Subject: Saxton Nuclear Experimental Corporation (SNEC)
Application for License Termination
Operating License No. DPR-4
Docket No. 50-146

**DISCUSSION ISSUES FOR MEETING BETWEEN THE NRC AND SNEC STAFFS
OCTOBER 31, 2002**

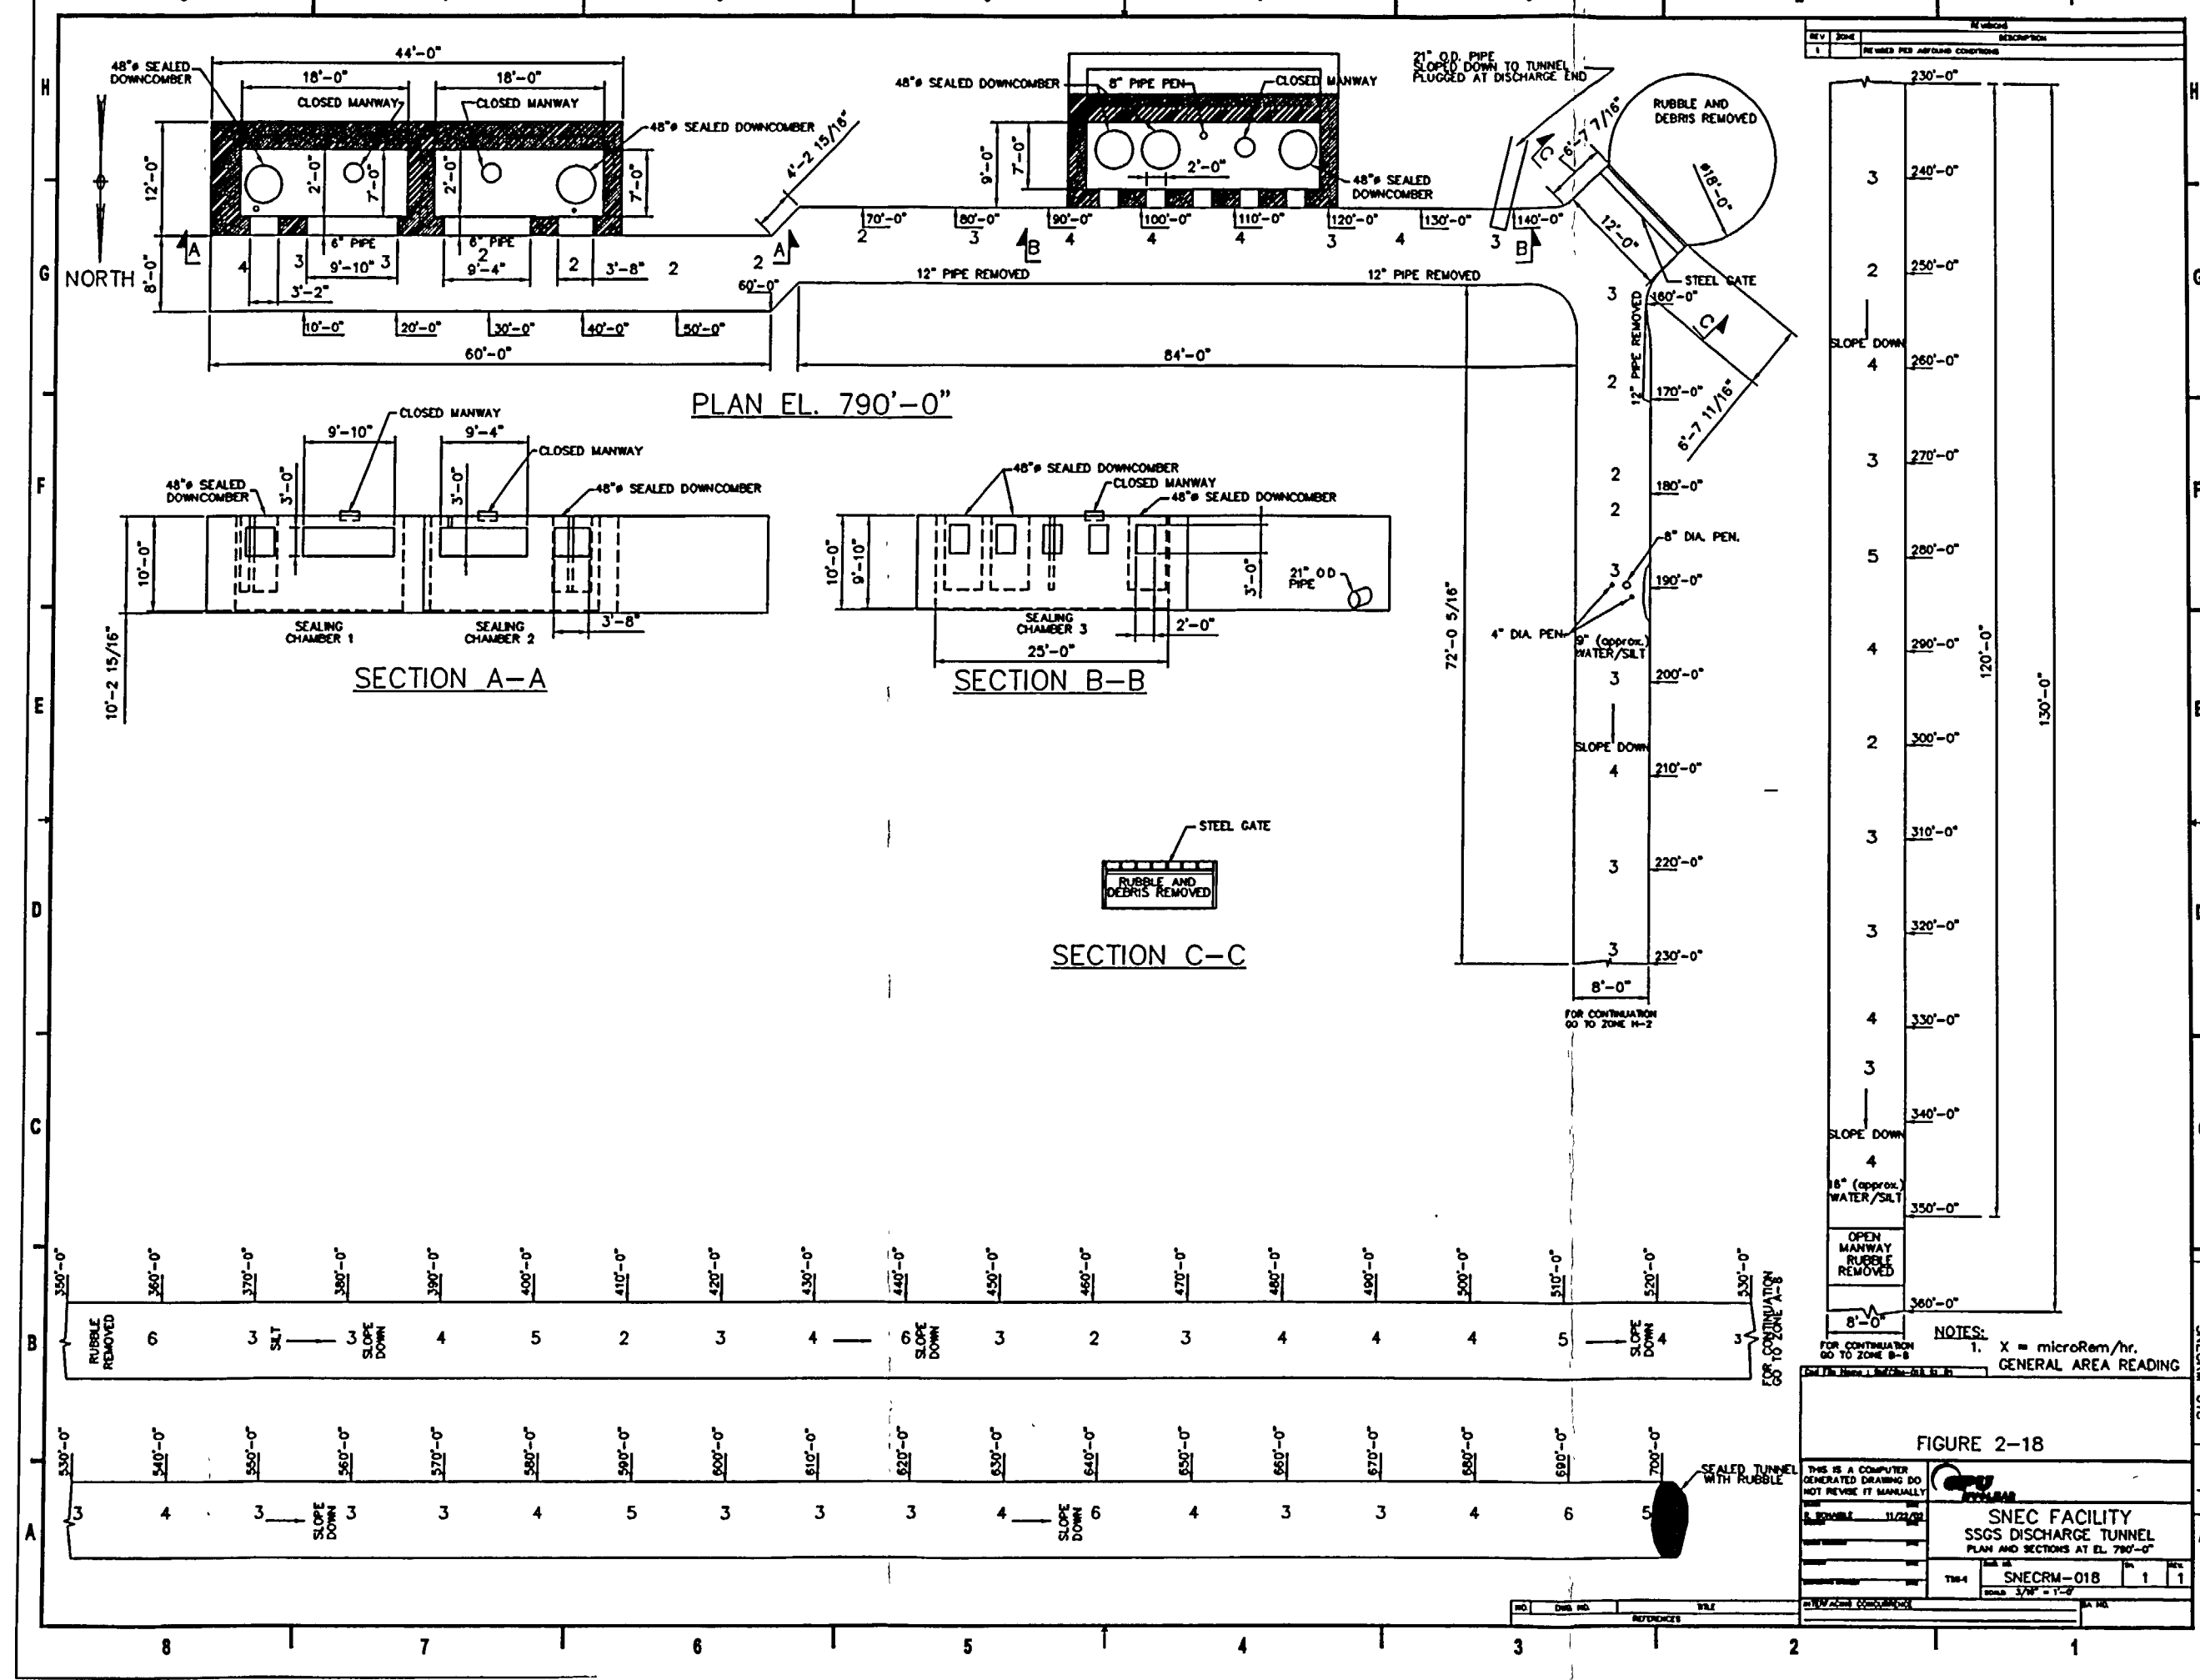
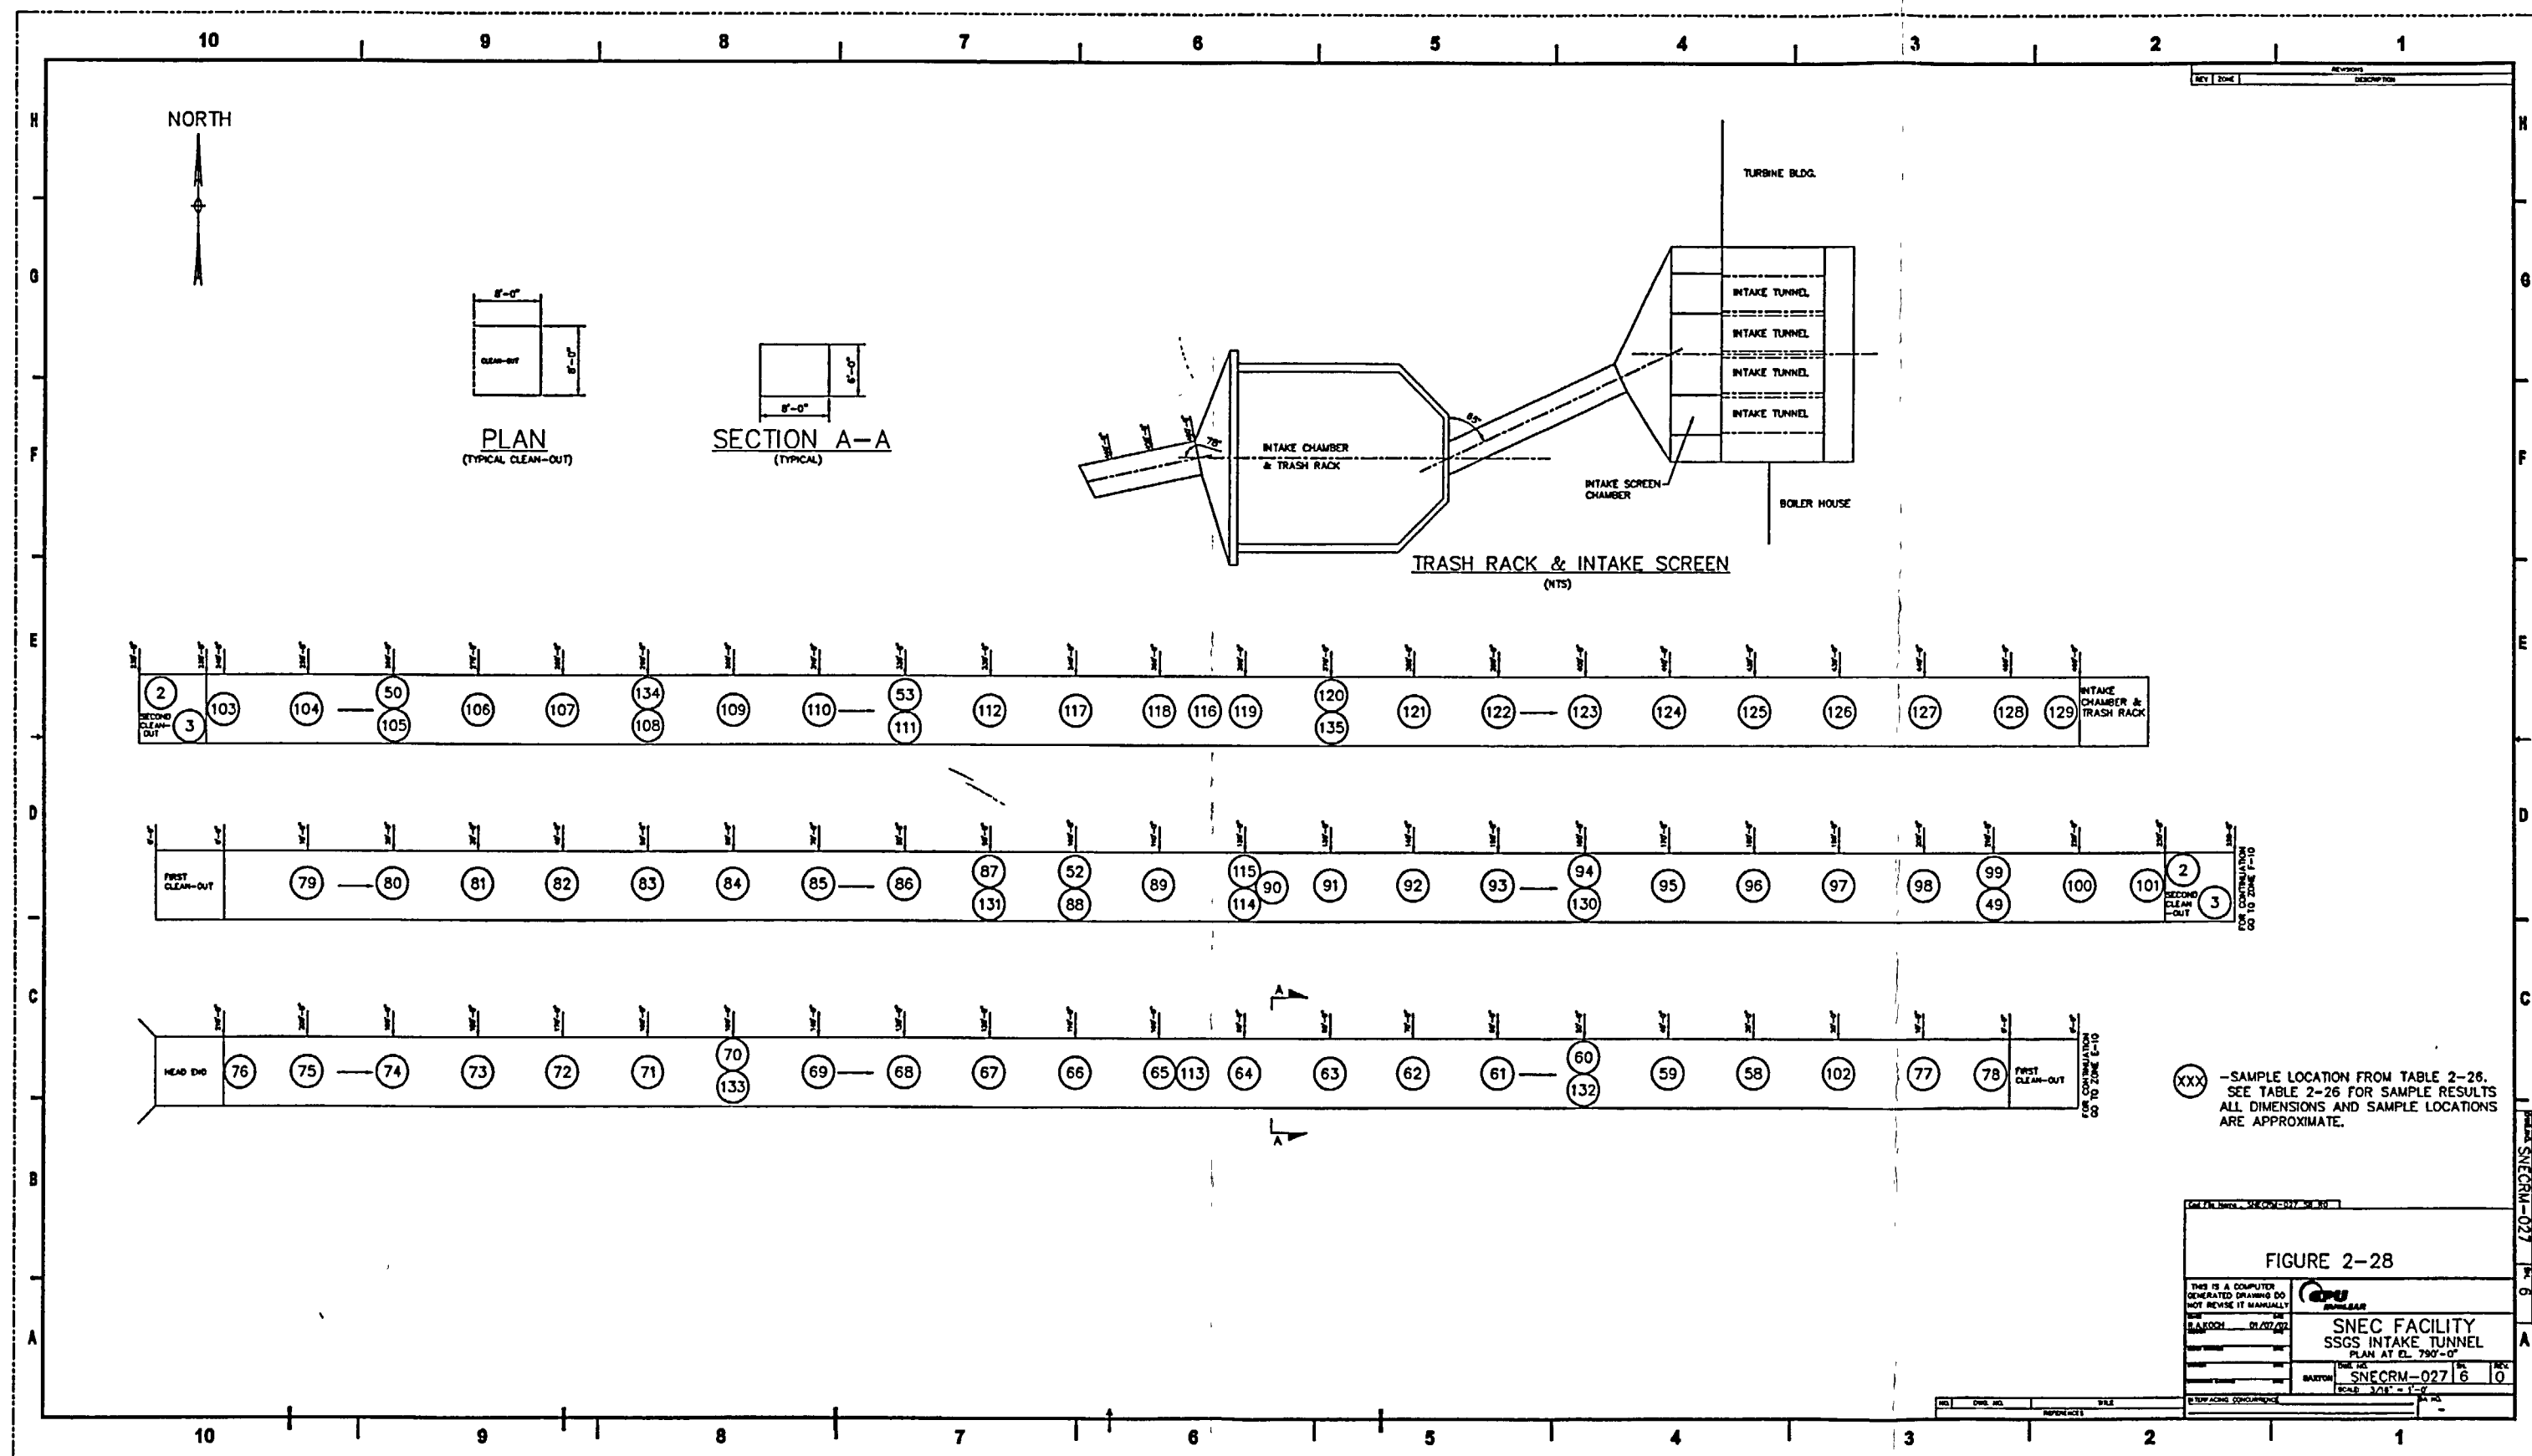
- c. Recent groundwater-level configuration maps representing the overburden and bedrock units. Also, discuss any changes in the groundwater-level configuration maps under drought and extremely wet conditions. The groundwater flow directions or patterns should be discussed and shown on the maps. The groundwater flow in the bedrock should also be discussed based upon observed water levels and the fractures and structural features in the bedrock units. (This information was not included in the LTP, but it was included in the items listed above.) The licensee should also provide a table that lists the groundwater levels over time at this site for the different monitoring wells. The licensee staff or consultants provided the NRC staff with a table with this information during the April 2002 groundwater sampling event. This table provides information on the variations in the groundwater levels during seasonal and wet and dry climatic periods.

Table 2-34 listing the most recent groundwater levels has been provided. In addition, Section 2.2.4.5.1, page 2-26, has been revised as follows to describe groundwater flows through the various geological units.
